# NMP | Landscape Architecture

Adamstown Boulevard - Phase I

RFI Response - SDZ22A/0007  
September 2022

## RFI Item 2.e

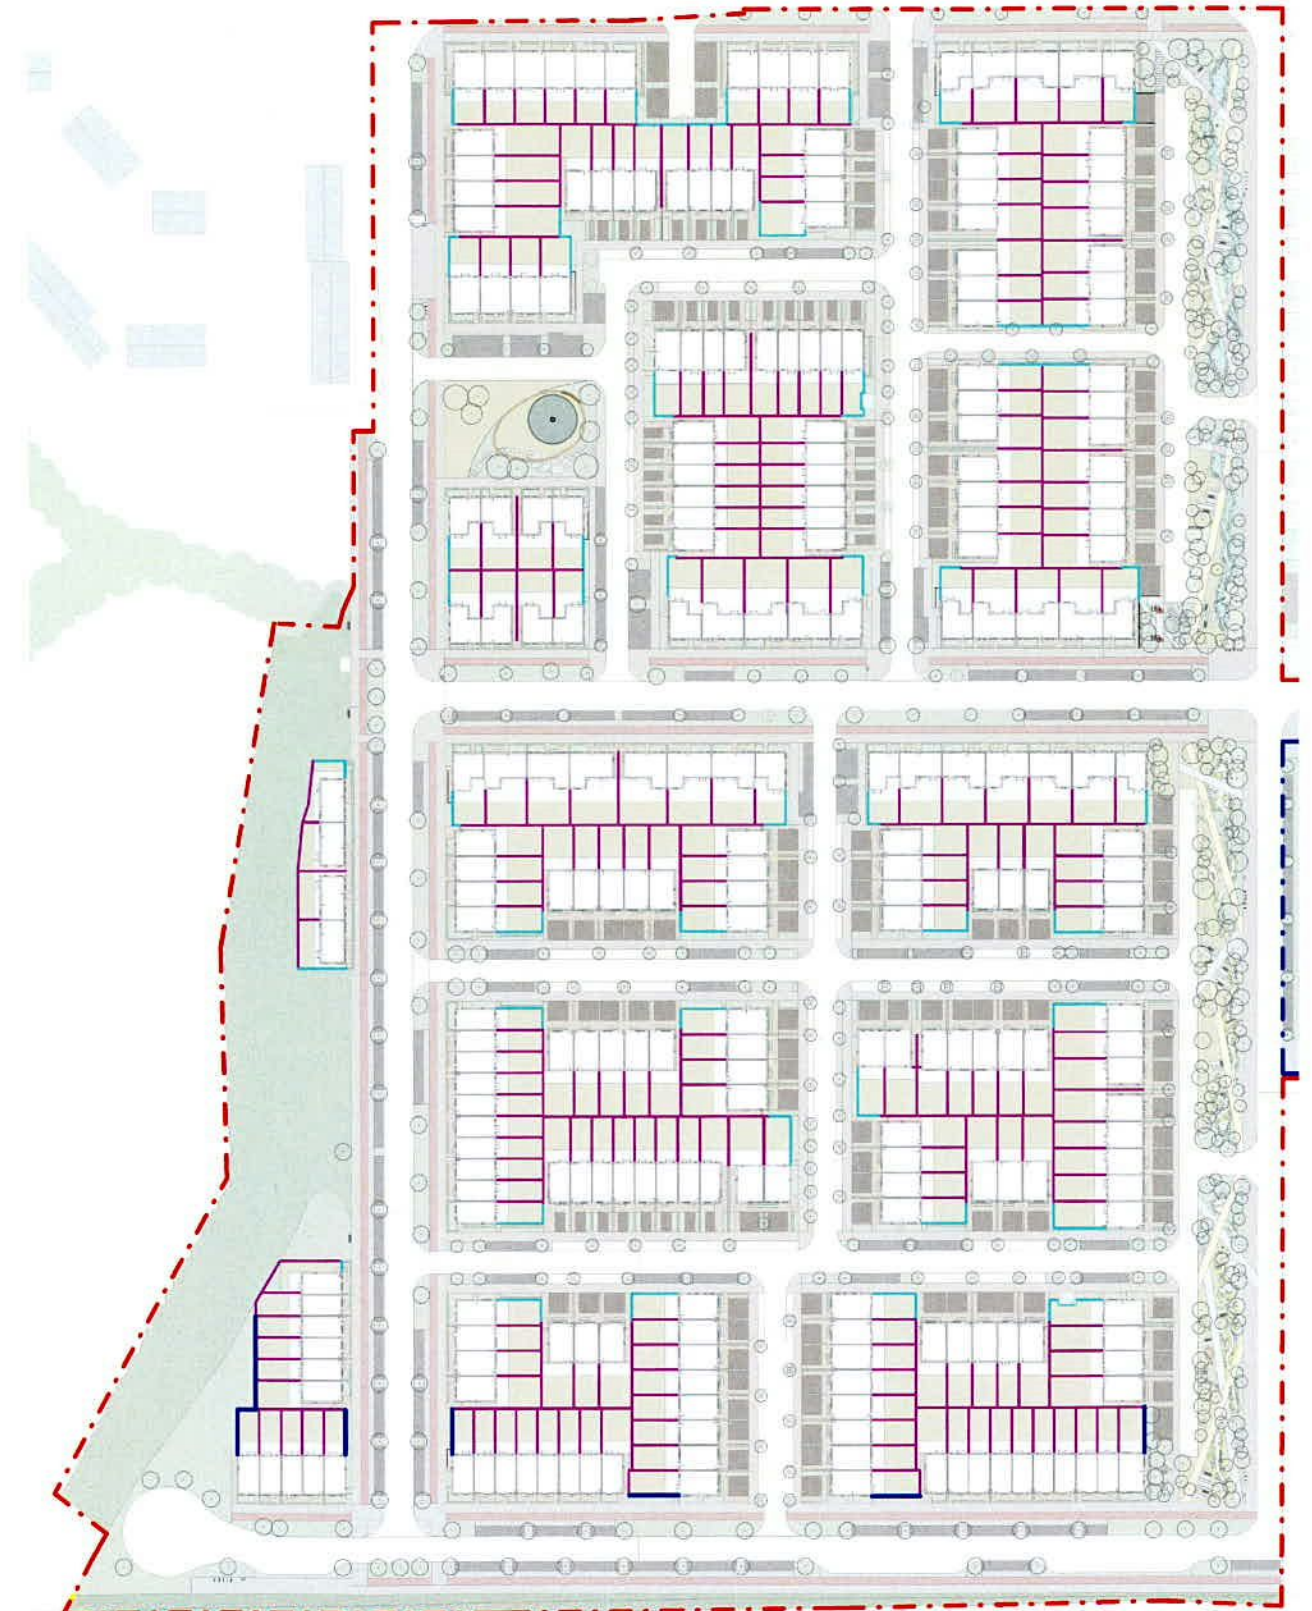
A statement outlining recommended acoustic control measures that should be incorporated into the design and construction of the proposed houses and/or site to ensure the use will not create adverse noise impacts on the occupiers. This should include parameters for walls, glazing, doors and ventilation for the proposed development.

Per the acoustics report by iAcoustics, the primary noise sources impacting the development is caused by road traffic and rail noise from the railways line running East-West to the south of the site. In order to mitigate noise exposure in private gardens due to train passing, we recommend a 2.4m solid block wall to be added at critical locations. Increasing the garden walls from 1.8m standard to the 2.4 block wall creates a noise barrier to rear gardens near the railway line.

In reference to RFI item no. 3b, the acoustic wall measure needs to be balanced with the careful protection of the hedgerow root protection area. Please refer to drawing no. *L1-101 - Permanent Boundary Conditions* for the proposed location of the block garden walls (at 2.4m and 1.8m) and timber slat fence (1.8m). Details for the block garden wall, please refer to architectural drawing A-45011.

*Paladin Fence*

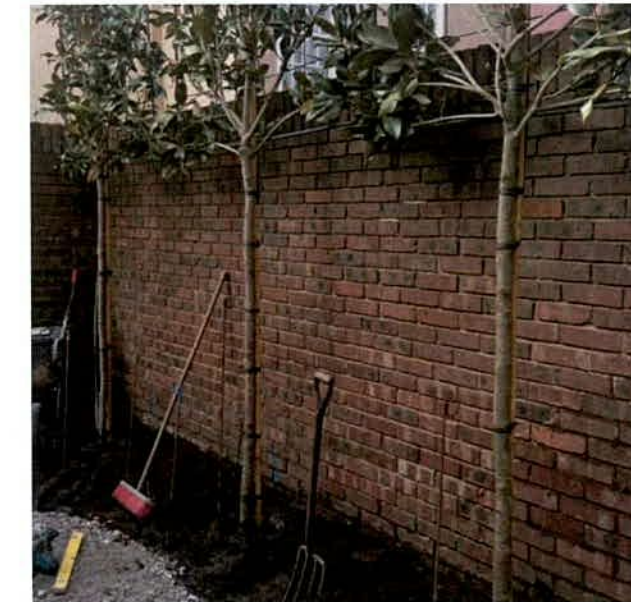
**3.b The applicant is requested to provide revised boundary treatment details / landscaping details for the boundary of the properties close to the hedgerow to the west**

Refer to *L1-102 - Temporary Boundary Conditions* plan indicates that a block and mesh fence will align 1-2m from the edge of the root protection zone for the existing hedgerow to protect the biodiversity during the construction phase. The existing oak tree located at the pocket park will also be retained and protected with paladin fence. Refer to details L1-902-4
